620535

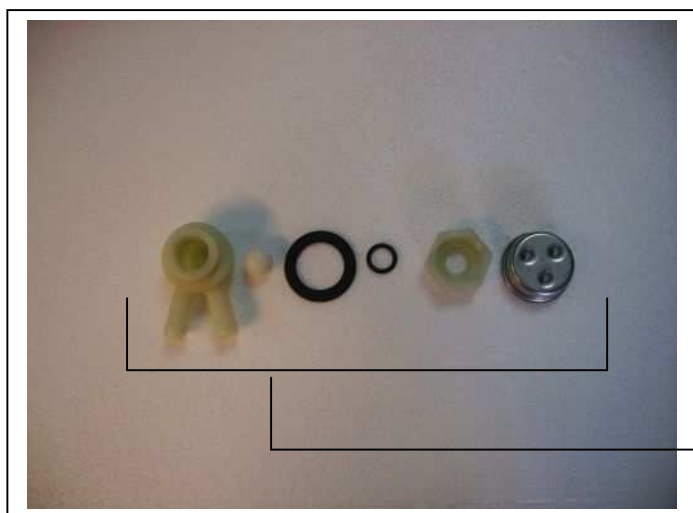
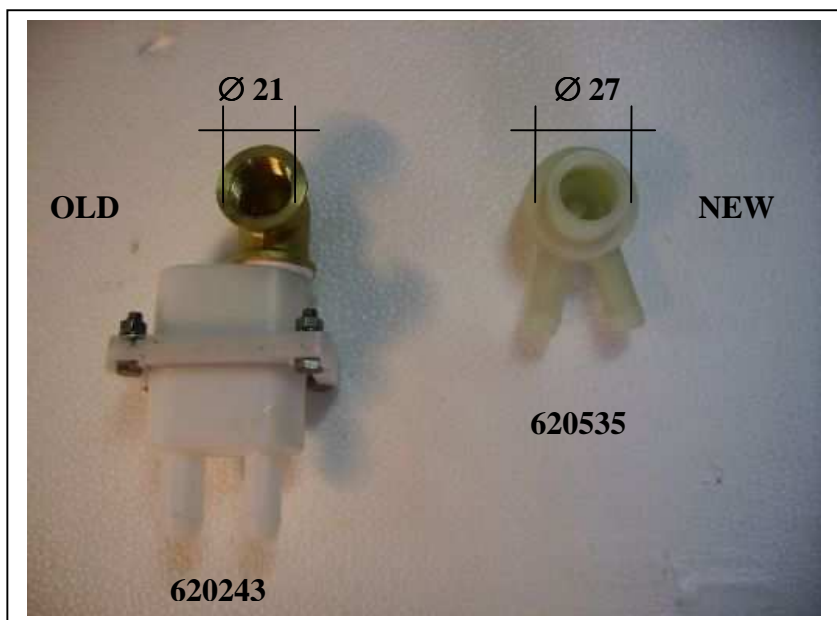
- LA VALVOLA ANTIVUOTO 620243 E' STATA SOSTITUITA CON IL NUOVO TIPO COD. 620535. PER IL MONTAGGIO ALLARGARE IL FORO DA Ø21 A Ø27

- VACUUM BREAKER 620243 HAS BEEN REPLACED BY NEW TYPE CODE 620535. BEFORE INSTALLING NEW VACUUM BREAKER FIRST CHANGE Ø21 TO Ø27

- ROHRTRENNER KODE NR.620243 ERSETZT DURCH KODE NR 620535. FÜR MONTAGE DAS LOCH BIS ZU Ø27 ERWEITERN

- LE CODE 620243 (CLAPET ANTIVIDE) A ETE REMPLACE PAR CODE 620535. POUR LE MONTAGE EVASER LE TROU JUSQU' A Ø27
